# LiDAR Quality Assessment Report

LA-USGS\_Atchafalaya2\_2012

LA\_Atchafalaya-2\_2012

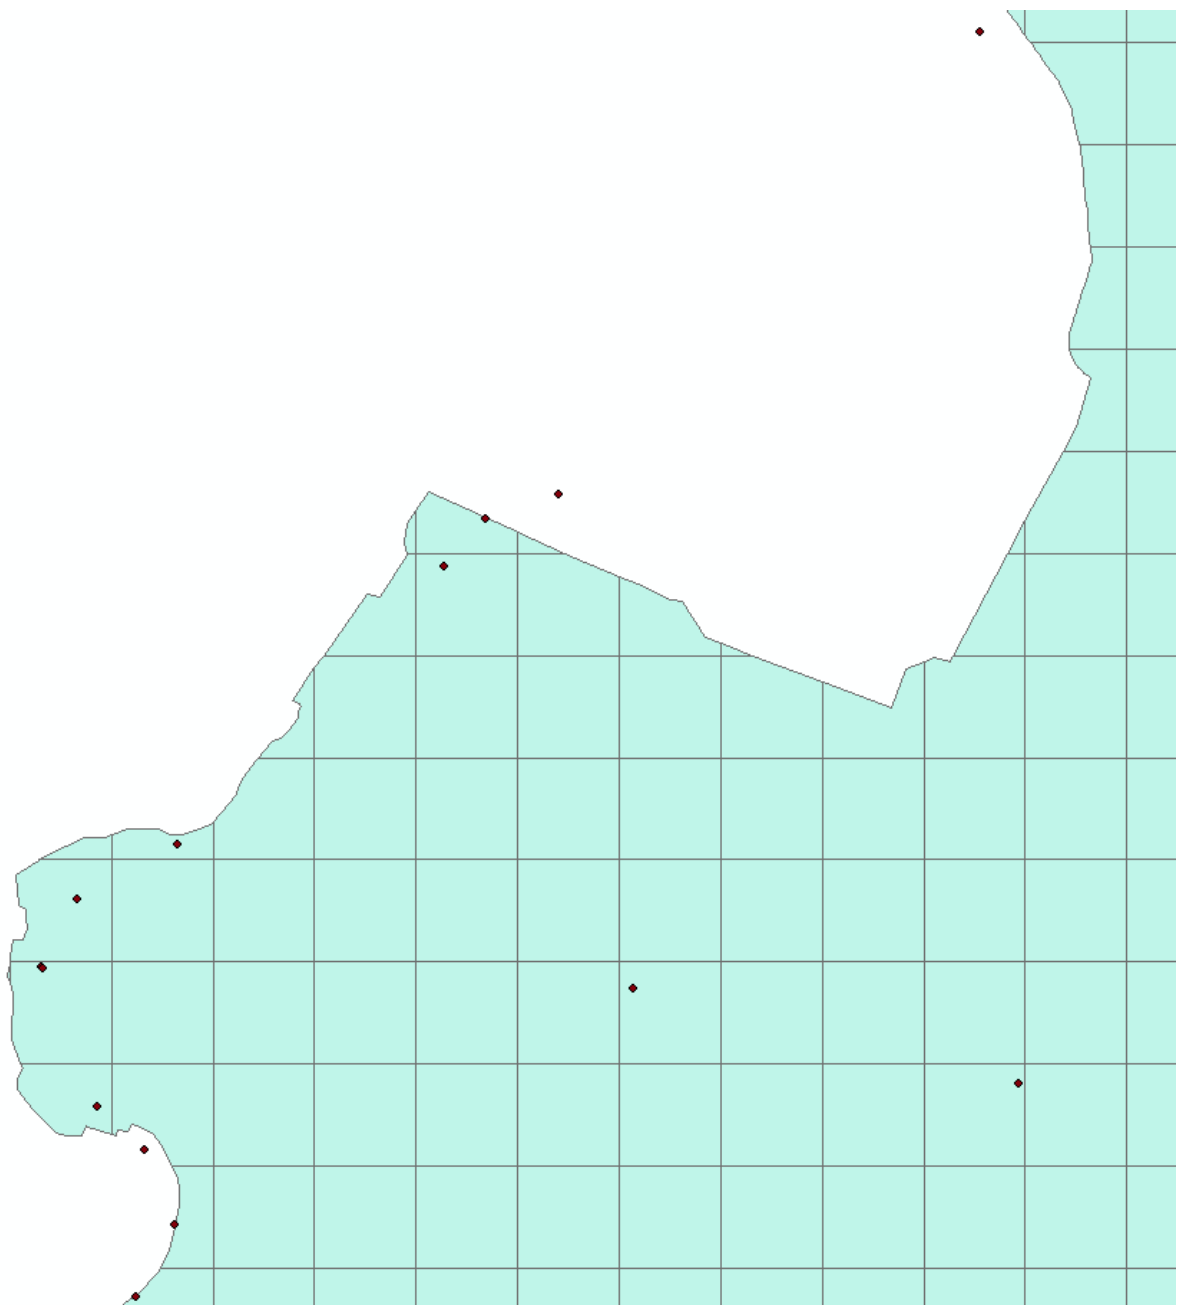
6 checkpoints fell outside the Project Extent. These checkpoints are; 4204, 4208, 4216, and 4217 which are classified as TALL WEEDS AND CROPS and checkpoints 5003 and 5004 which are classified as BRUSHLAND AND TREES. Examples of some of the checkpoints outside the extent are shown above.

\*\*\*The Vendor corrected these outliers by eliminating them from the checkpoints. This still exceeds the minimum requirement of 20 checkpoints per category for the project.

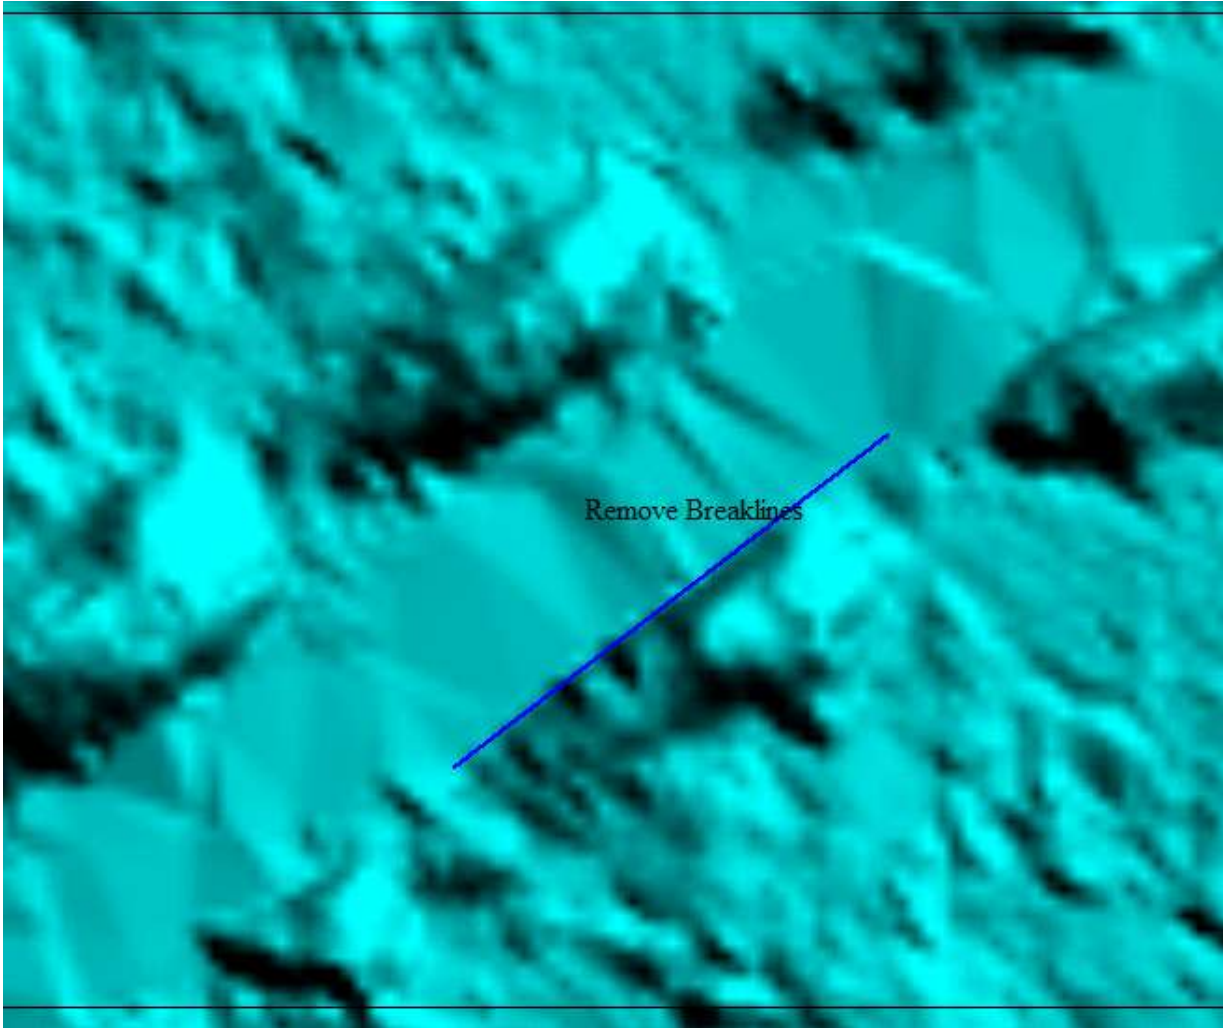
Remove unnecessary Breakline.

\*\*\*Vendor corrected the image above.

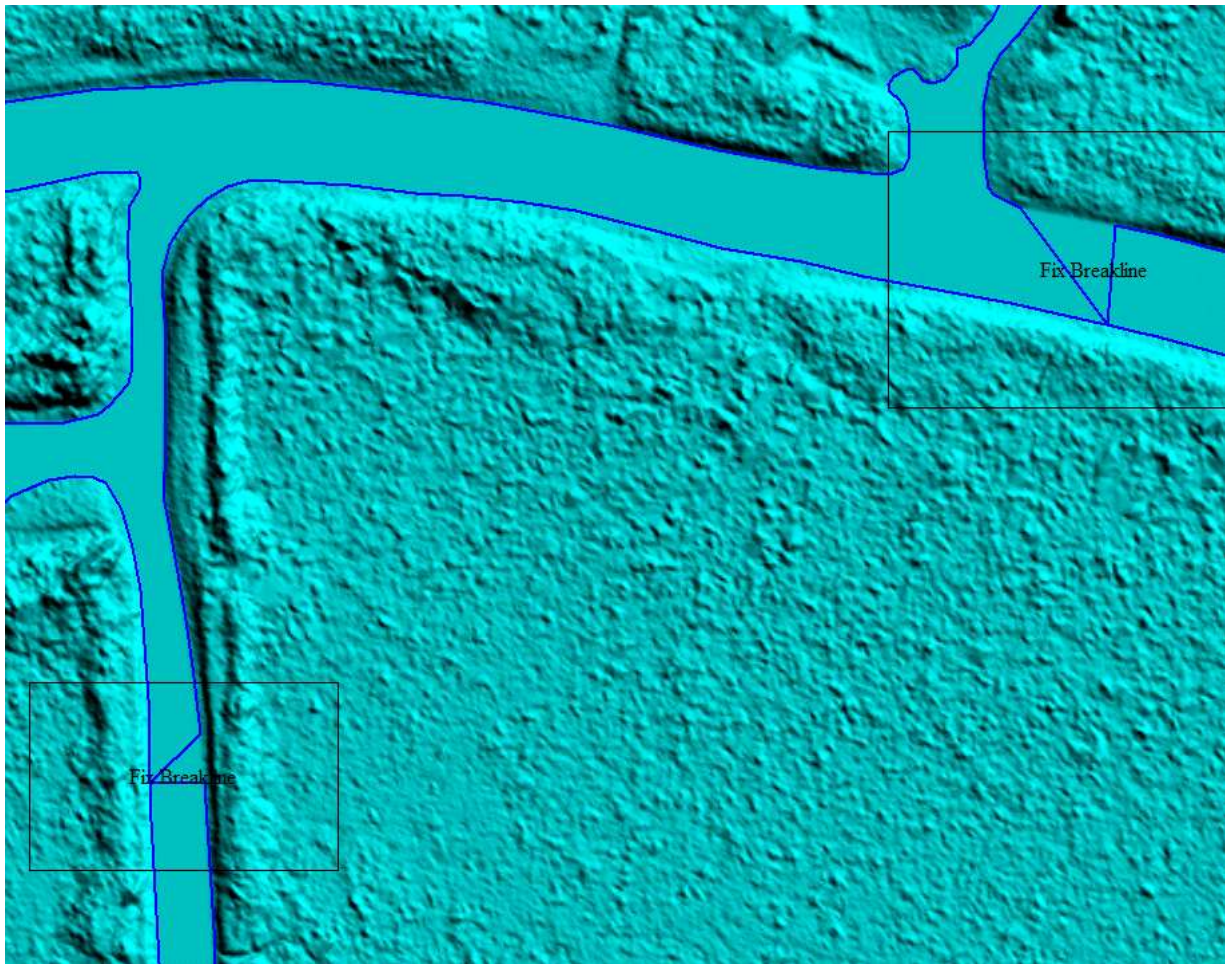
Fix Breaklines. Delete or move Vertex snapped to opposite Breakline.

\*\*\*Vendor corrected the image above and others like it.

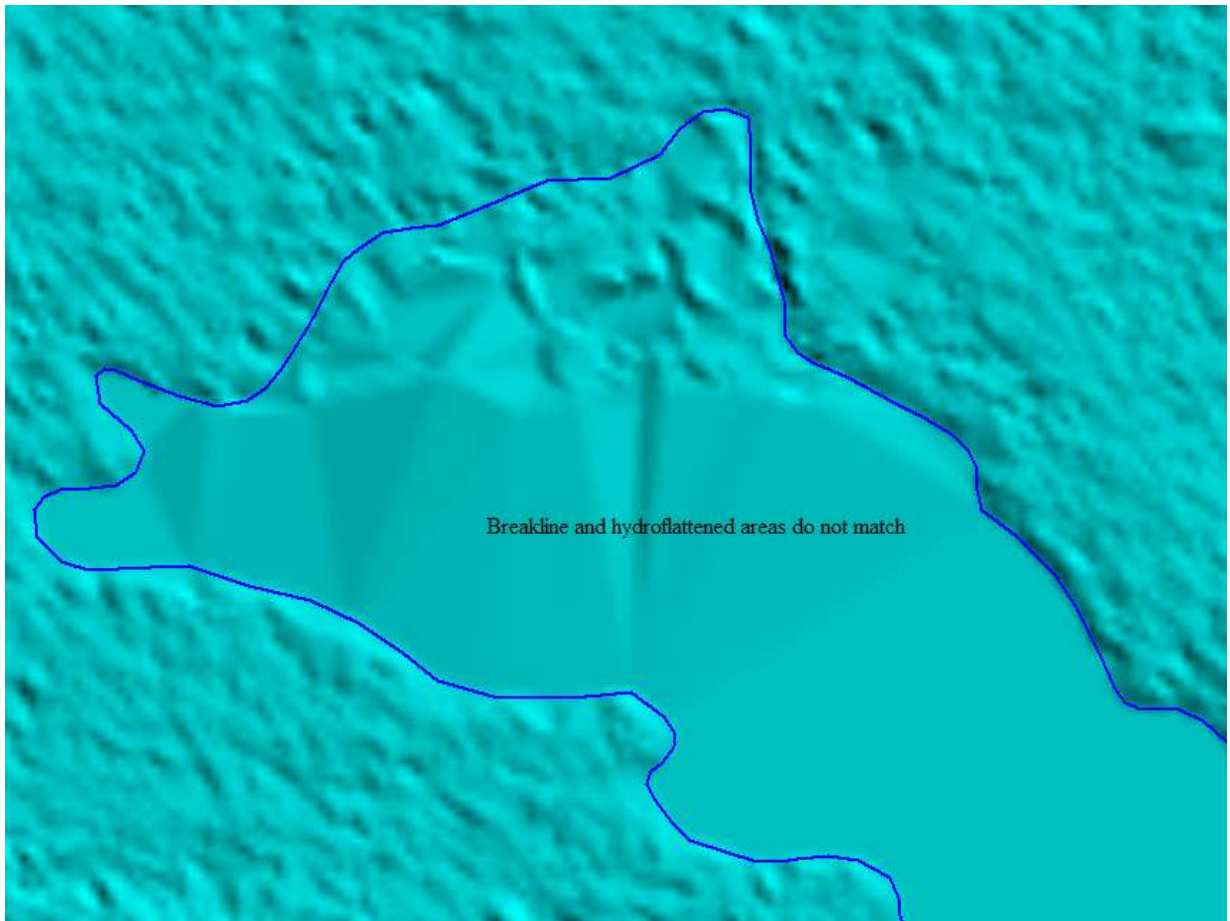
Breakline and Hydroflattened areas do not match.

\*\*\*Vendor corrected the image above and others like it.

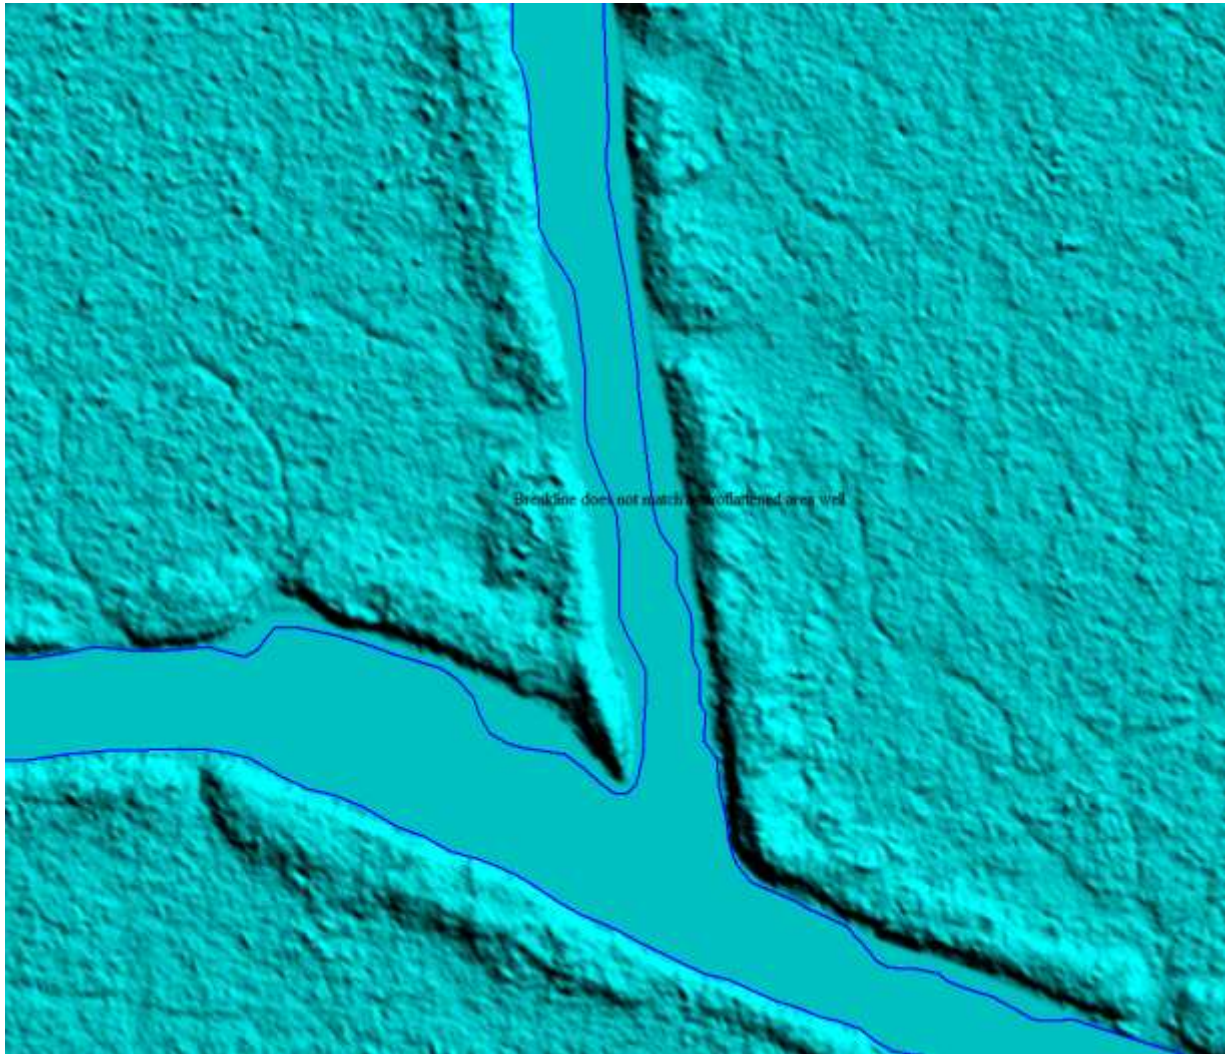
Breaklines do not match Hydroflattened areas well.

\*\*\*Vendor corrected the image above and others like it.

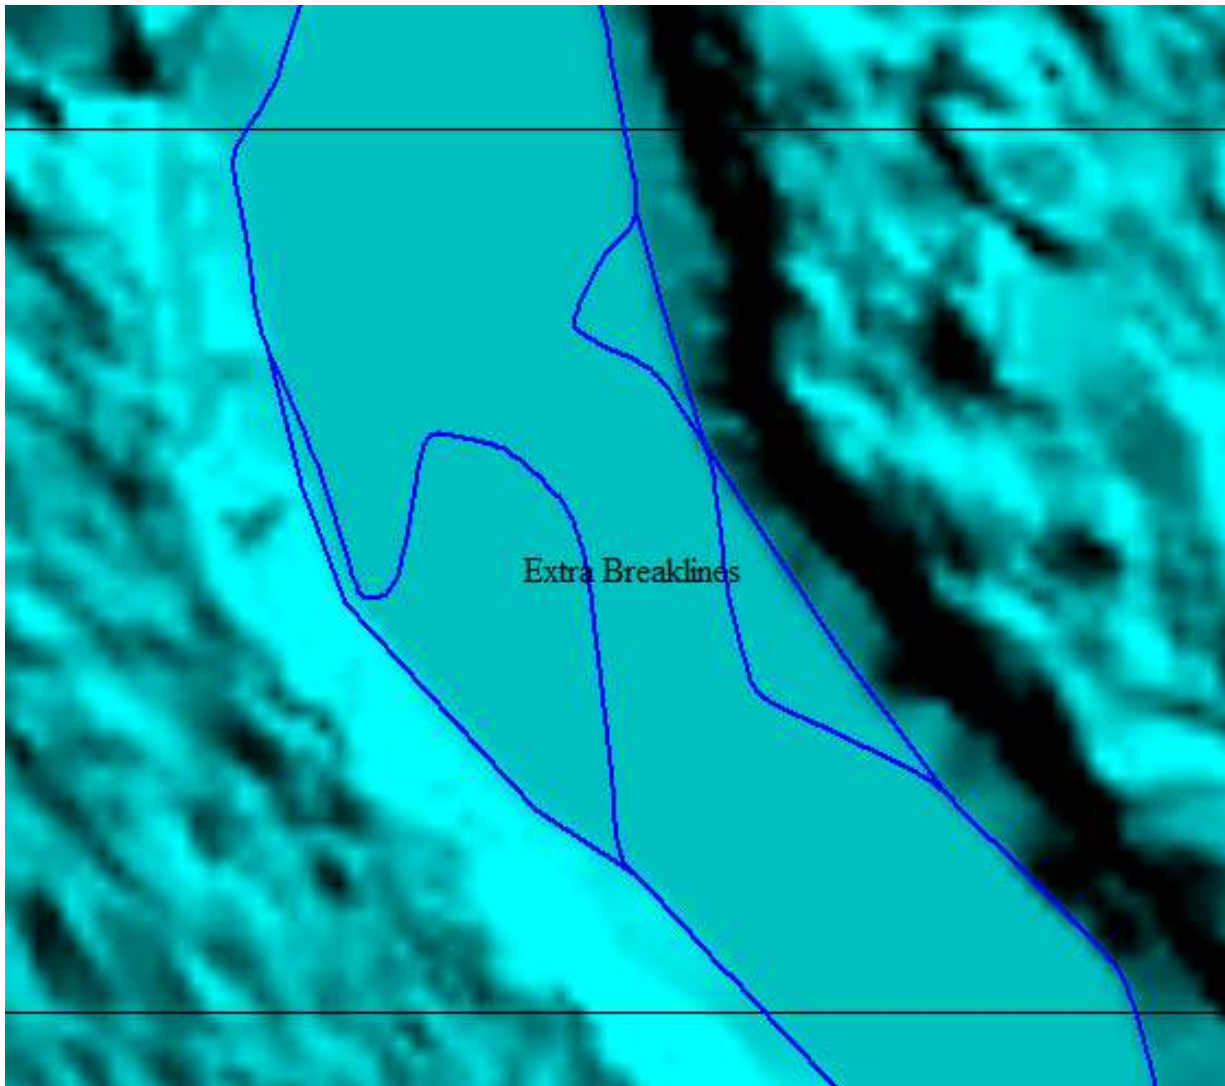
Remove extra Breaklines.

\*\*\*Vendor corrected the image above and others like it.

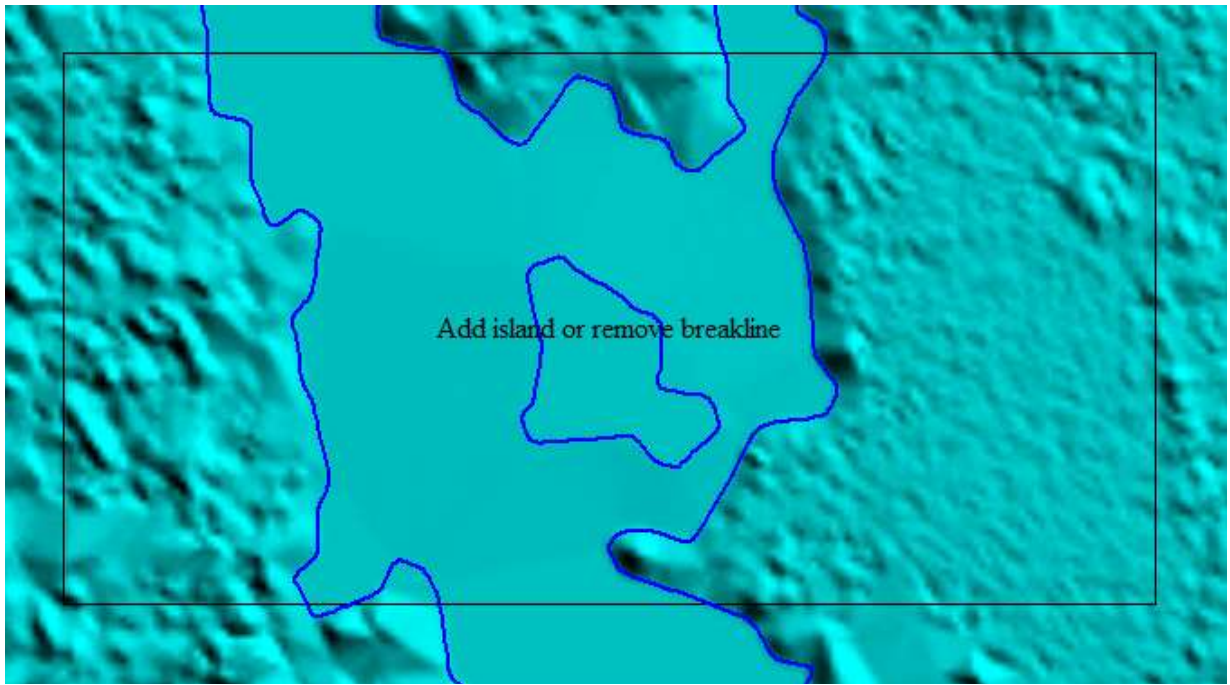
Add island or remove breakline.

\*\*\*Vendor corrected the image above and others like it.

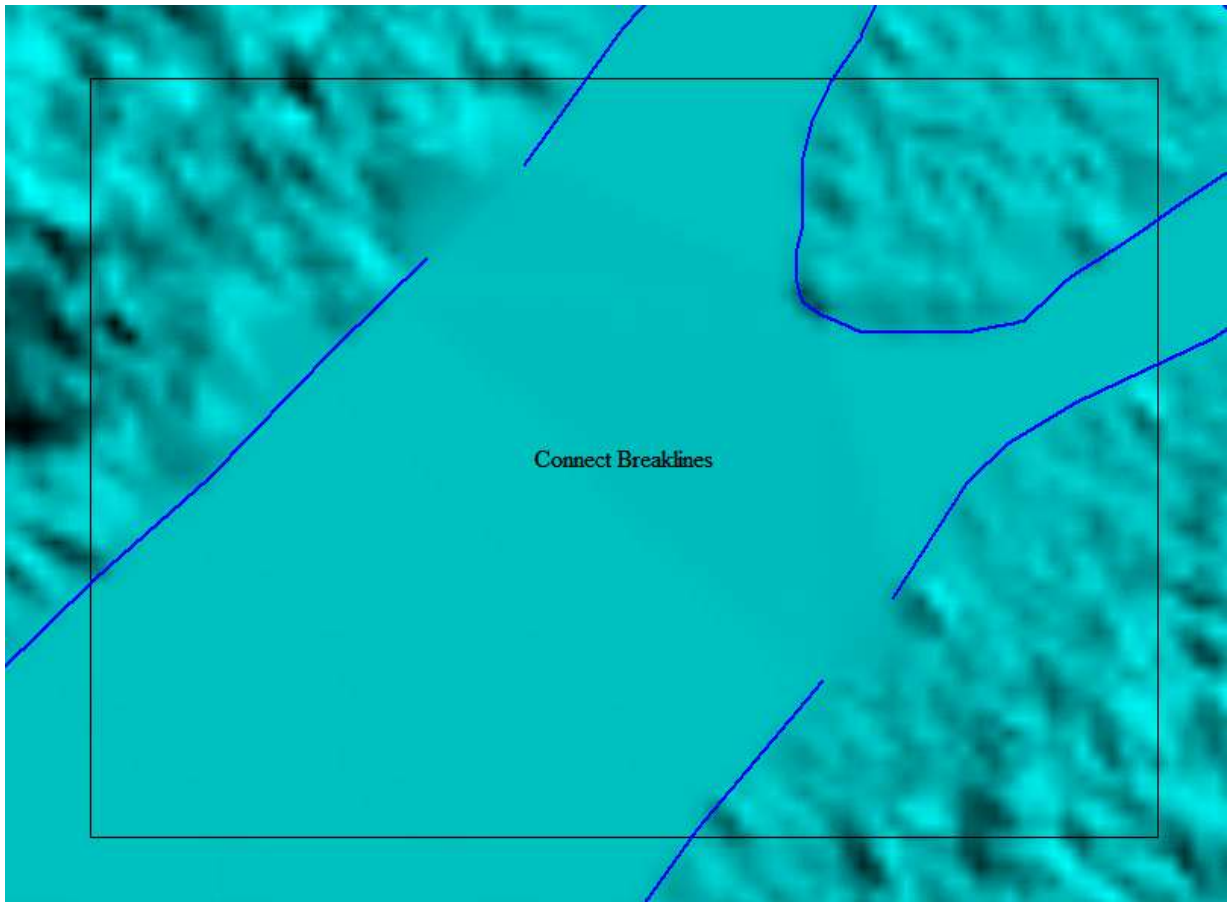
Connect Breaklines.

\*\*\*Vendor corrected the image above and others like it.

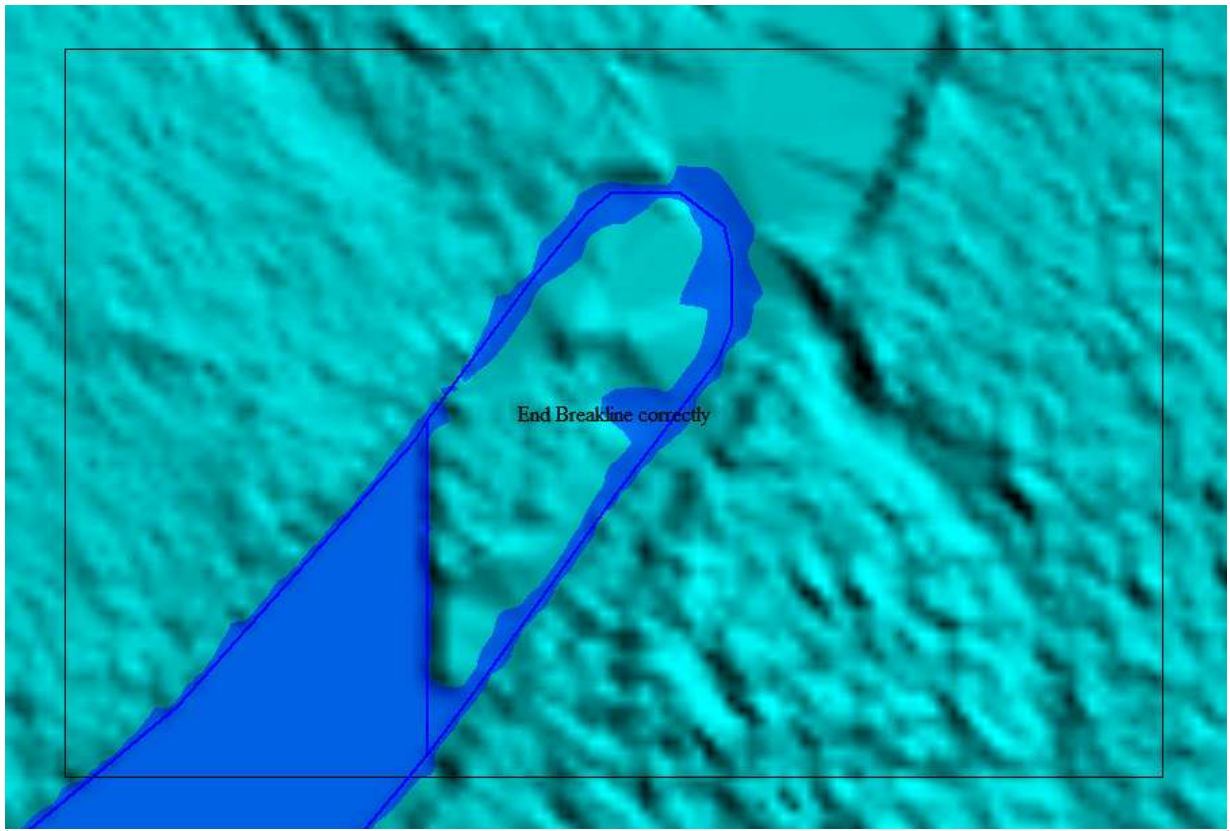
Hydroflatten area in Breakline.  
\*\*\*Vendor corrected the image above and others like it.
